Proposed Development at 1-3 and 4, 6 and 8 Ferdinand Place Daylight and Sunlight

Thank you for issuing the formal objections submitted to the London Borough of Camden in response to our mutual clients planning application for the above site, reference 2016/ 2457/P.

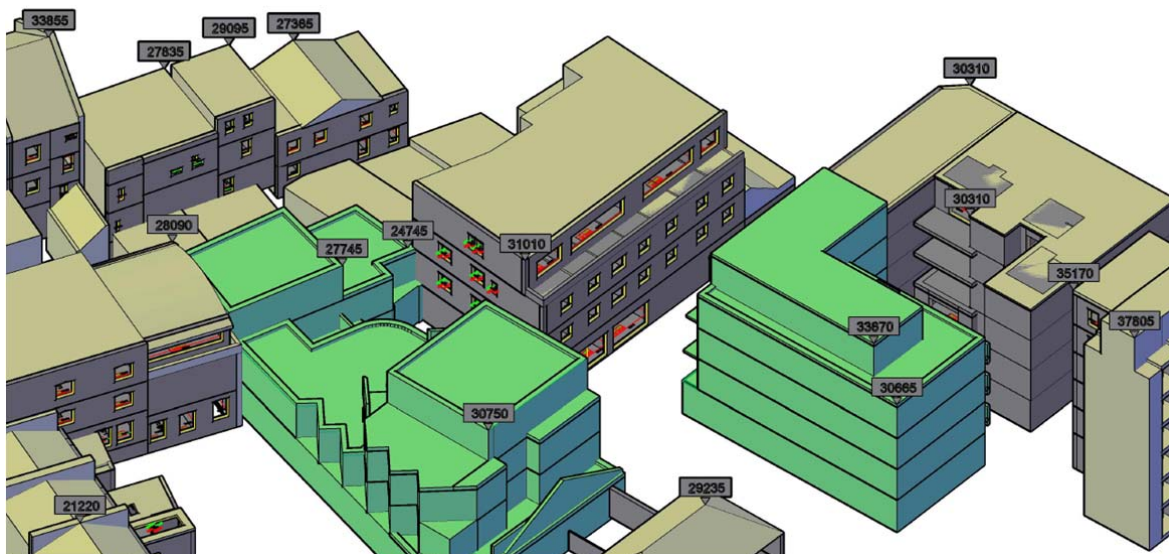
The objection states Anstey Horne concluded that there will be a significant and unacceptable reduction.

Optic Realm has concluded the proposed development could not be described as similar in height terms to its neighbours.

In order to understand the relationships in more detail, GVA has undertaken bespoke spot height analyses of the proposed development and its immediate context, inserted below for ease of reference.

As can be seen the existing surrounding buildings are in some cases slightly taller and in other cases slightly lower, but overall the proposed development could not be considered to materially differ in terms of height.

On this basis, Anstey Horne would presumably concur with GVA's approach to applying alternative target values based on realistic expectations of dwellings in the immediate area, as set out in the BRE guidance, and therefore acceptable.

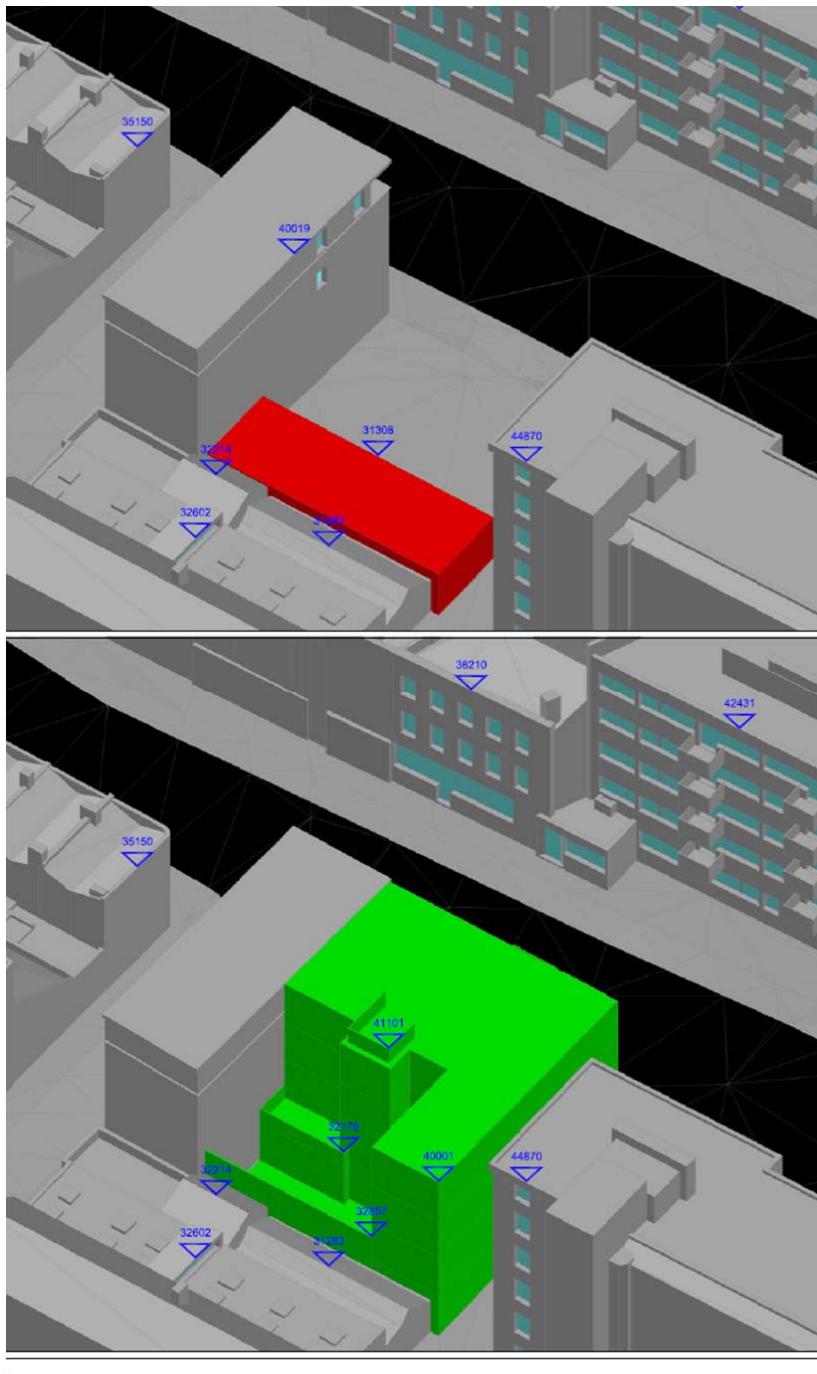
The objection in respect of this property is that GVA have not considered a sufficient number of windows and that the results for those windows assessed show significant reductions where facing the development site.

GVA undertook desktop research of this property, which confirmed that windows serving habitable rooms on the north facing elevation were blocked up as part of Optic Realms development of the former garages directly adjacent.

For ease of reference an extract from Optic Realms Daylight and Sunlight study for the former garages site is shown below.

The top image illustrates the three windows at 10 Ferdinand Place on the boundary serving habitable rooms.

As can be seen in the bottom image, all three were completely enclosed upon by Optic Realm's development.

The remaining windows all serve non-habitable areas, such as stairs, as illustrated on the plans below.

As such the BRE would not recommend applying the guidance in respect of Daylight and Sunlight, hence not being assessed by GVA.
